Ford Motor Company

## Design Change

### China CDX707 DAT Subscription SYNC+ IVI Enrollment and Unenrollment

Version Date: 21<sup>st</sup> Apr 2022

### 3.4. IVI/HMI Enrollment Functional Requirement

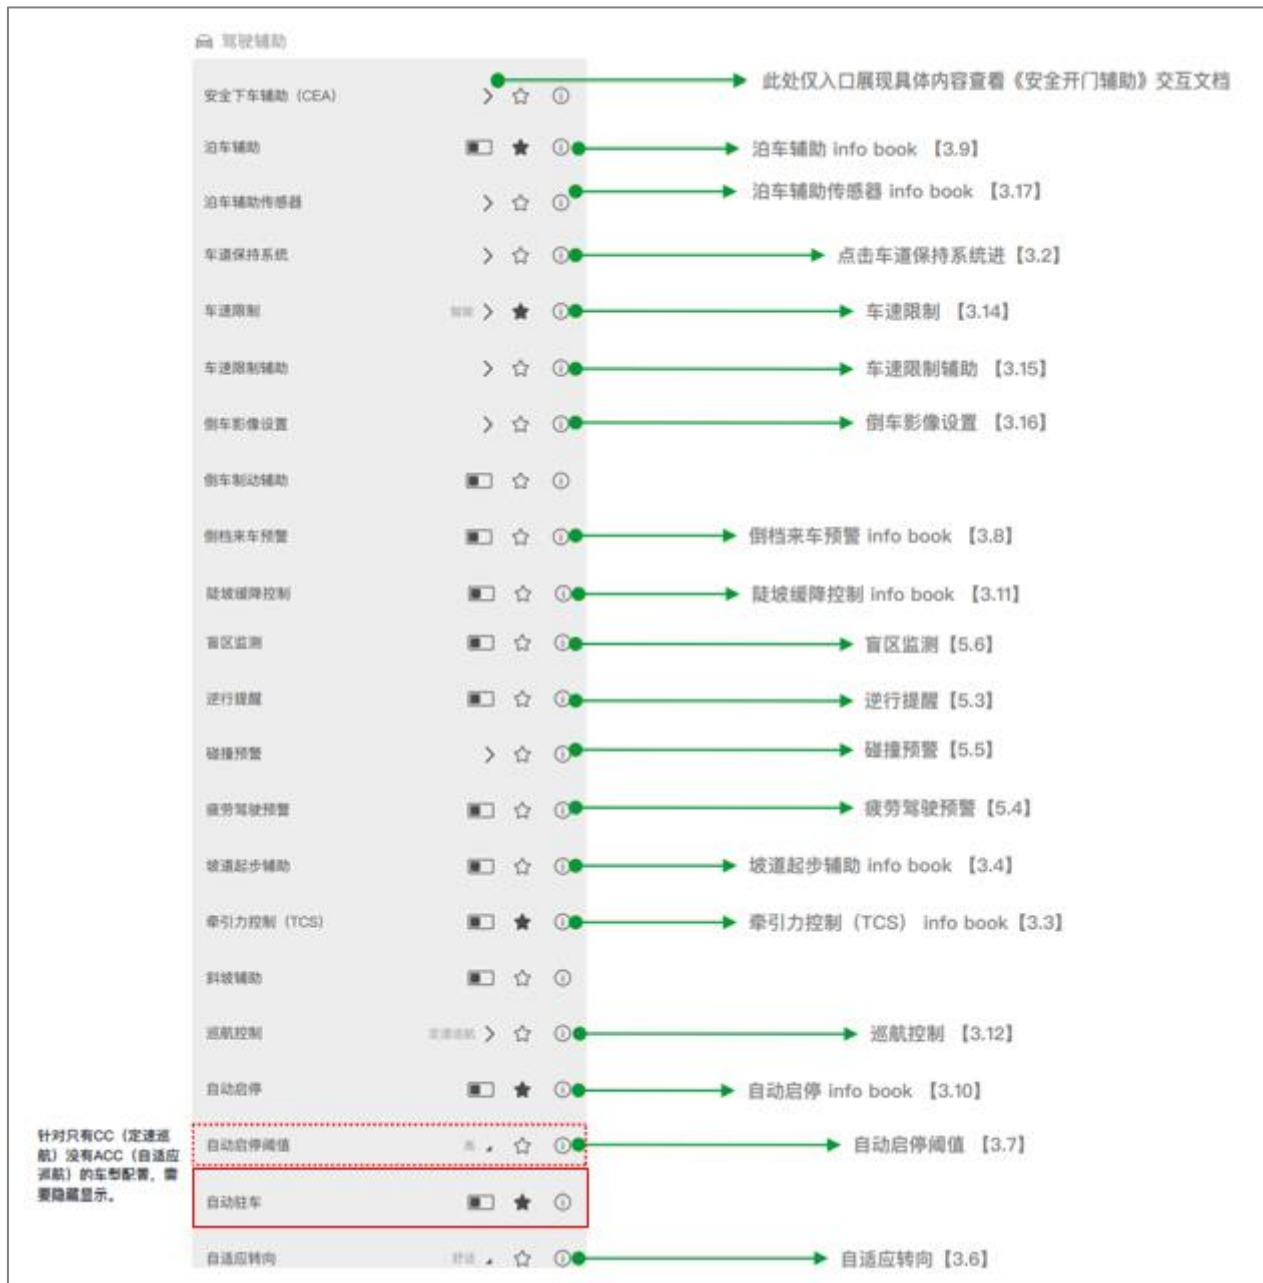
- The client of CCS SYNC+ IVI needs to broadcast the status of subscription through lib-data-bus. The function module of **ADA and APA** in IVI need to get the setting of the CCS DID by themselves and display the regular function page of **ADA/APA** in next ignition cycle.
- “ActiveGlide” is the temporary market name for core ADA feature, subject to future changes

ADA (“ActiveGlide 主动驾驶服务功能” switch will be on)

APA ("自动驻车" switch will be on)

- If the value of DID CCS in lib-data-bus is null/undefined, the HMI of **ADA** and **APA** functions in IVI should be same as the status of pervious ignition cycle.
- Popup message when CCS DID of any one of below 2 features is not null/undefined and changed from 0 (unenrolled) to 1(enrolled) see table below

- Popup message title: “状态更新”
- Text: “您的林肯 Co-pilot 智行驾驶辅助状态已更新。 **ActiveGlide** 主动驾驶辅助状态：[已开启]；**APA** 一键泊车辅助系统状态：[已开启]”
- (the parameter is displayed according to current IGN cycle DID)
- Button: “查看详情” click and navigate to feature detailed page
- Message level: 4
